Historic Architectural Review Commission Staff Report for Item 2

Application Number: C2025-0057

Address: 417 Elizabeth Street (rear)

Description of Work:

Proposed South Elevation.

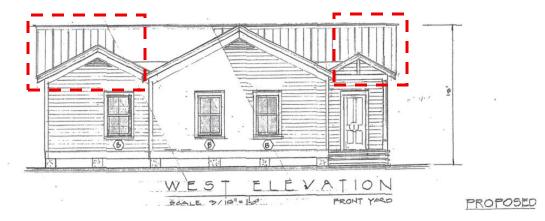
On the south elevation, the applicant proposes an 8' x 24' gable roof extension within the existing building footprint, along with the removal of existing jalousie windows to be replaced with 2-over-2 windows. The west elevation will feature a new covered entry porch with a gable roof, 2 over 2 windows, and a half-glazed entry door. The north elevation shows the proposed addition, which includes new window types of varying sizes and configurations. It features a triangular clerestory-style window at the gable, as well as two tall narrow windows, and a 2 over 2 window adjacent to the right side of the addition.

Proposed West Elevation.

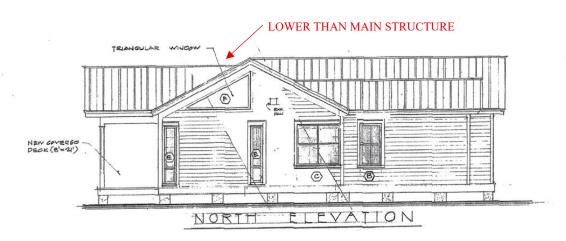
The proposed alterations raise some concerns with the HARC Guidelines. The existing roof is being significantly modified and extended across multiple elevations to accommodate new additions (especially seen on the east and west elevations outlined in red). According to Guideline 4 under *Roofs*, the form, pitch, materials, and shape of a roof must not be altered unless restoring it to a verifiable historical form. Guideline 1 of *Additions* states that Additions shall require no or minimal changes to the character defining features of a building and its site. Guideline 20 of *Additions* states that expanding the existing building form and massing in order to add height to exterior walls is not an appropriate design solution. Guideline 24 of *Additions* discourages the use of same wall plane or cornice height.

Staff recommends that the proposed roof additions seen on the east and west elevations be revised to be lower than the existing roofline to maintain the historic hierarchy and massing of the structure.

Existing East Elevation.

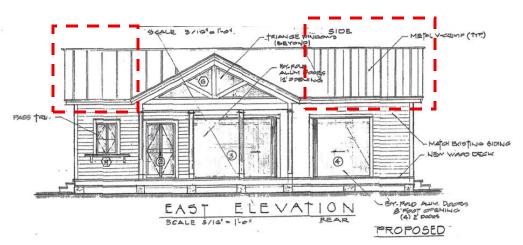
The east elevation includes a proposed IPE wood deck and a new gable roof structure with decorative truss detail. The design features two sets of aluminum bi-fold doors, a 12-foot opening at the center and an 8-foot opening at the right side, along with a pass-through window on the left and a triangular clerestory-style window located behind the gable truss.
